**STATUTORY PLANNING COMMITTEE**  
**21 SEPTEMBER 2009**

<b>1.</b>	<b>45 AND 47 HOTHAM STREET, EAST ST. KILDA</b>
<b>ADDRESS:</b>	<b>45 and 47 Hotham Street, East St. Kilda</b>
<b>PROPOSAL:</b>	<b>Partial demolition, alterations and additions to existing buildings, construction of a three storey building at the rear with a total of 20 dwellings and provision of 18 car spaces</b>
<b>WARD:</b>	<b>Carlisle</b>
<b>NEIGHBOURHOOD:</b>	<b>East St. Kilda</b>
<b>TRIGGER FOR COUNCIL REPORT:</b>	<b>More than 15 objections</b>
<b>APPLICATION NO.:</b>	<b>439/2009</b>
<b>APPLICANT:</b>	<b>Hotham Street, P/L</b>
<b>EXISTING USE:</b>	<b>Residential</b>
<b>ABUTTING USES:</b>	<b>Residential and sub-station</b>
<b>ZONING:</b>	<b>Residential 1</b>
<b>OVERLAYS:</b>	<b>HO 292</b>
<b>STATUTORY TIME REMAINING FOR DECISION AS AT DAY OF COUNCIL</b>	<b>Expired</b>
<b>RESPONSIBLE MANAGER:</b>	<b>George Borg, Manager City Development</b>
<b>AUTHOR:</b>	<b>Phillip Beard, Senior Statutory Planner</b>

**GROUND FLOOR PLAN**

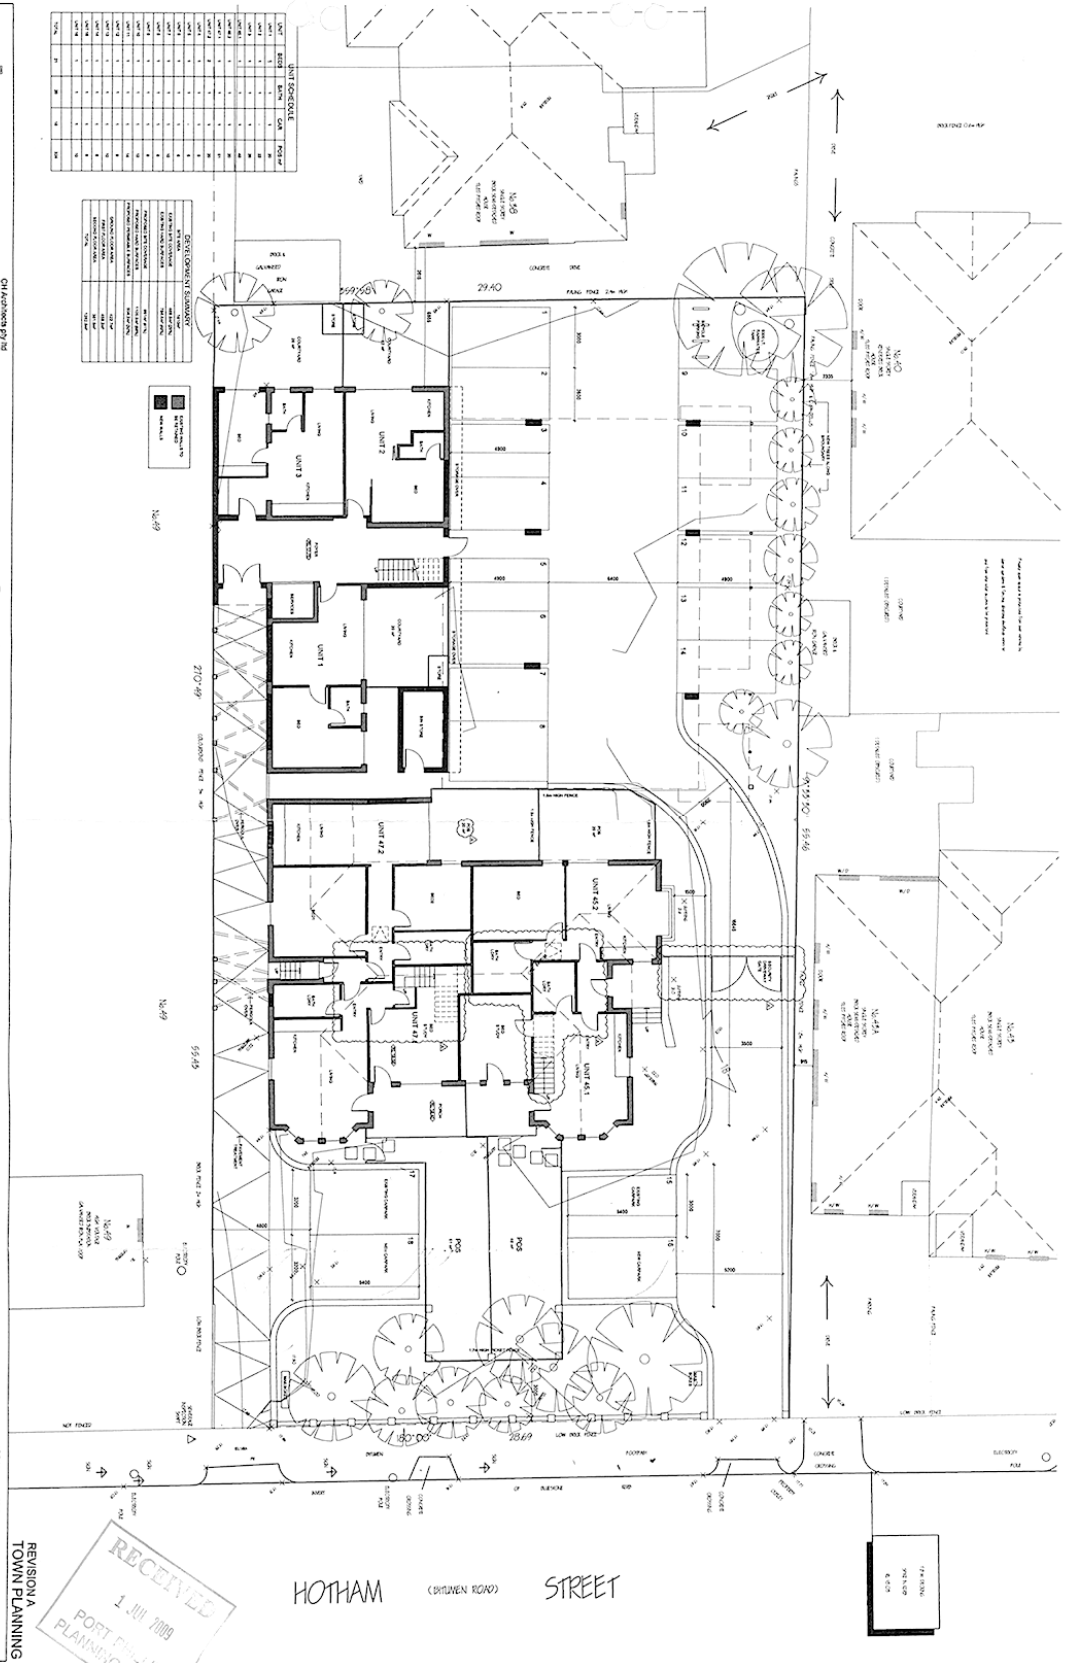
- 2.5. The proposal at ground level would comprise two shared pedestrian and vehicle entrances from Hotham Street. These would utilise the existing crossovers. Both of these would lead to car parking areas within the front setback, each area consisting of two car spaces at 90° to the driveways. The southern driveway would be shared for a distance of approximately 13m beyond which it would be for exclusive pedestrian use. This accessway would serve the main foyer of the rear building and two of the front dwellings. It would include a 7m x 5.2m passing bay within the front setback. Beyond this point, the driveway would be 3.5m wide.

- 2.6. The northern driveway would be shared for a distance of approximately 17m. The shared section would give access to the remaining two front dwellings and the rear car park area. This area would contain 14 car spaces arranged either side of a 6.4m wide central aisle.

The location of car parking in the front setback of a heritage building is not normally supported. In this instance, the condition currently exists in an informal way with cars parked either side of the dwelling's front façade. These parking areas are accessed by two crossovers which would be utilised by the proposal. Subject to appropriately low fencing and driveway paving, formalising the front parking arrangement is considered acceptable. Refer conditions 1 (b) and 1 (h).

Driveway widths and car space dimensions all meet appropriate standards.

**ELEVATIONS**  
**PROPOSED RESIDENTIAL DEVELOPMENT**  
**45-47 HOTTHAM STREET, ST. KILDA EAST**

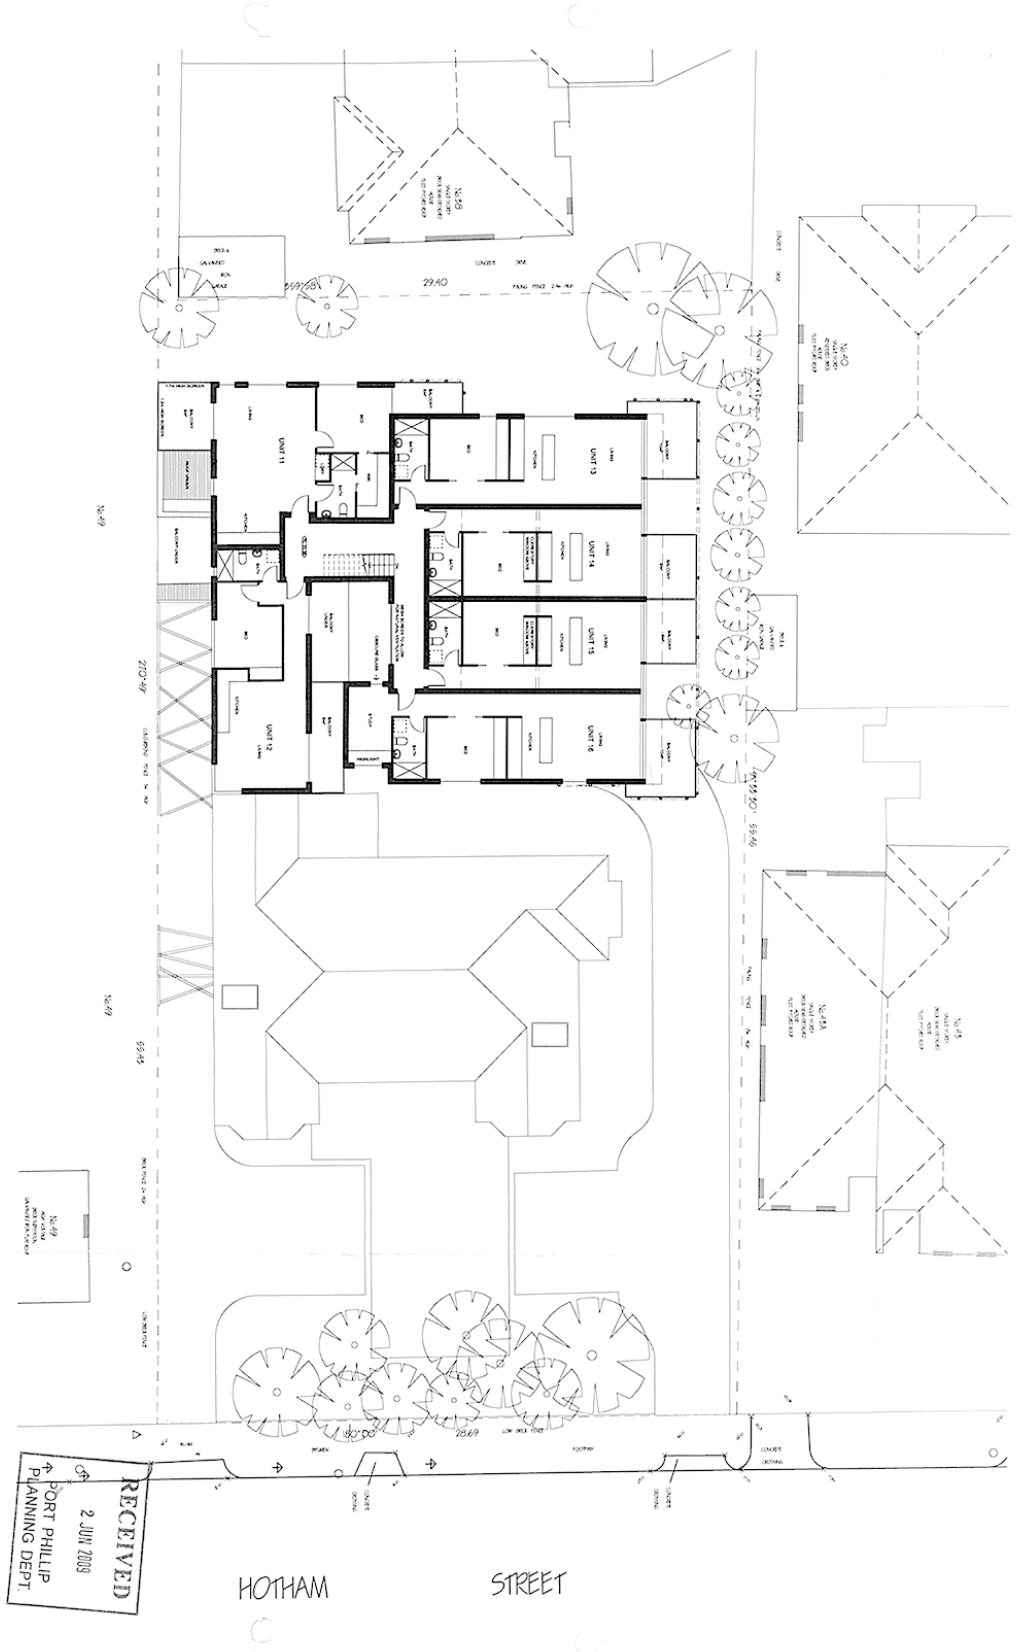
The proposal would, however, create an unacceptable degree of change in terms of its response to the end of Westbury Grove to the rear and would create a highly rectangular and clearly visible form imposing upon that street. Whilst only impacting upon a small pocket of Westbury Grove, it is considered that the proposal would not adequately respond to this issue and a reduction of the building's size is recommended at condition 1(a).

West and north windows and balconies have been depicted with 1.7m high louvre screens, obscure glass or sills to that height and full height obscure patterned glass. It is recommended that details of the balcony screens and the patterned glass be submitted such that they would achieve zero transparency and that their outward projections be depicted on the elevations. Refer conditions 1(d) and 1(e). This would protect the privacy of nearby properties.

*(iii) The main concern in regards to the front setback relates to the fencing for the private open space. The heritage integrity would be compromised as a result of the fencing which is intrusive, proposed at 1.7m. Note that the fencing was not shown on the East elevation submitted. It was only annotated as a detail.*

1. Before the development starts, amended plans and elevations to the satisfaction of the Responsible Authority must be submitted to and approved by the Responsible Authority. When approved, the plans will be endorsed and will then form part of the permit. The plans must be generally in accordance with the submitted and advertised plans but modified to show the following:
